DOCKET ITEM #11

Coordinated Development District Concept Plan #2015-0001

Development Special Use Permit #2014-0033

3809-3839 Mount Vernon Avenue (Parcel Address: 3809, 3809-A, 3811, & 3811-A Mount Vernon Avenue) and 3907 Bruce Street – Mount Vernon Village Center

Attachment 4: Exhibit 1, Condition 3k: Street Trees

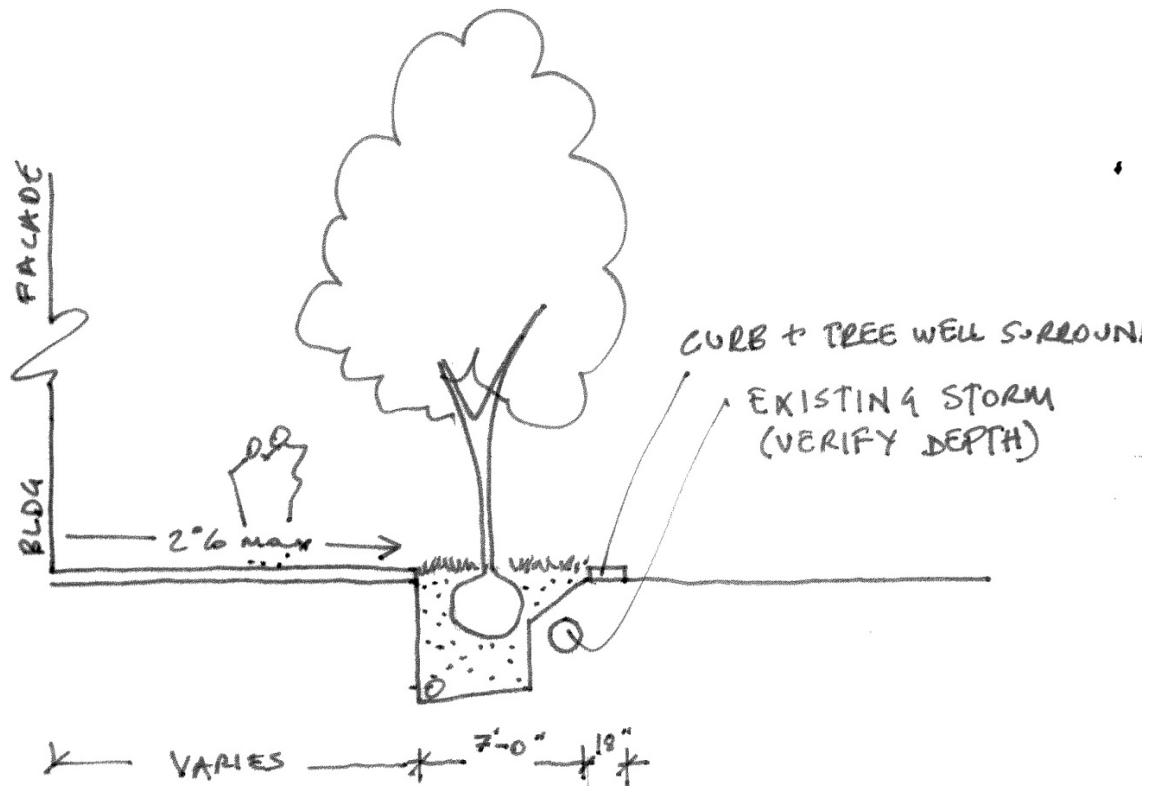
- j. No garden walls shall be constructed within the park property line. (P&Z)(RP&CA)
 - k. Provide street trees along the full frontage of Mount Vernon Ave. Locations to be determined at final site plan. In the area with potential conflict with the underground storm pipe, provide verification of the pipe depth and tree wells generally consistent with *Exhibit 1 (Attachment 4)* to the satisfaction of the directors of RPC&A and P&Z. Relocation of the existing stormwater pipe will not be required. (P&Z)(RP&CA)*
